Technical Bulletin - Safe Movement of Cabins Using a Forklift Truck

With immediate effect to meet the requirements of the Lifting Operations and Lifting Equipment Regulations (LOLER) all our cabins will now have the addition of fork pockets. The addition of the fork pockets will allow for the safe and easy movement of our units in our manufacturing facility and during the transport and siting of the cabins.

What do unit base rails look like without and with fork pockets?

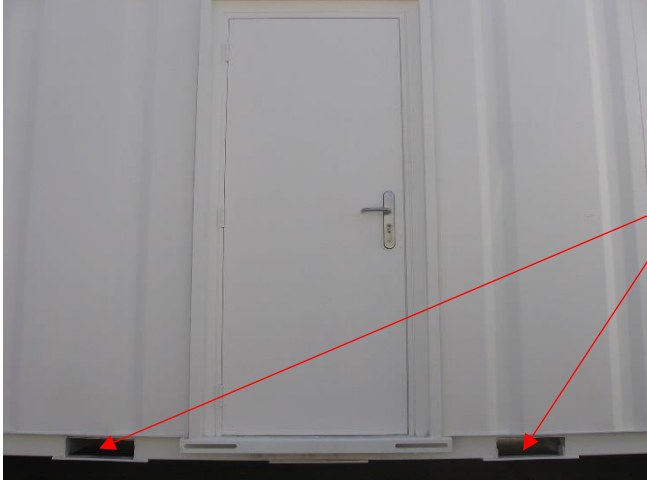
We have considered all options and had concluded that fork pockets are the most sensible solution to avoid the risk of an unstable load. ***There will be some exceptions i.e., Modular, and large bespoke units.***

Without these pockets there is a potential to cause damage to the cabins as the forklift truck operator tries to slide the forks under the cabin, the driver must judge the point balance which depending on design, may not be the dimensional centre of the cabin.

Main Point for Information	Photo Example	Proposed Change
		Fit Fork Pockets at 1800mm Centres here
Base Rail fitted with Fork Pockets		Fork Pockets fitted at 1800mm Centres here
